RADIATION SAFETY & CONTROL SERVICES, INC.

**REVIEW OF THE GROUND WATER  
PROTECTION PROGRAM  
AT THE FORT CALHOUN NUCLEAR POWER  
STATION**

**TSD #08-015**

# Review of the Ground Water Protection Program Fort Calhoun Nuclear Power Station Fort Calhoun, Nebraska

Figure 1

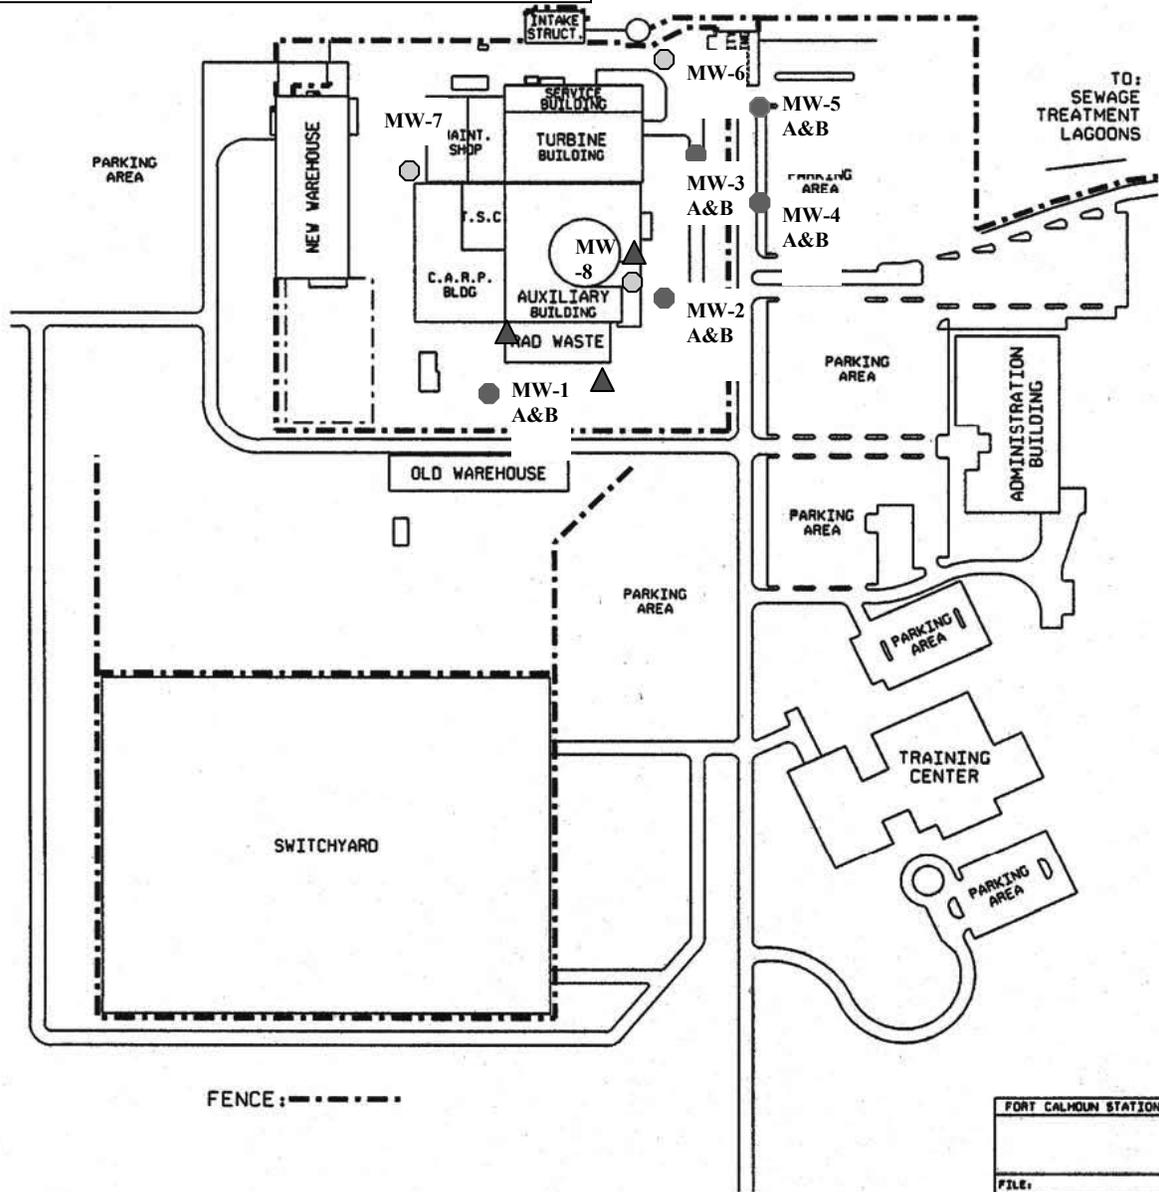
1. Drill an additional two shallow monitoring wells near the southwest exterior wall of the radwaste building, in locations recent testing has shown are down-gradient of the spent fuel pool and safety injection refueling water tank. These SSCs are potential sources of release to the environment of radioactive liquids. Figure 1 shows the locations of the proposed shallow wells.
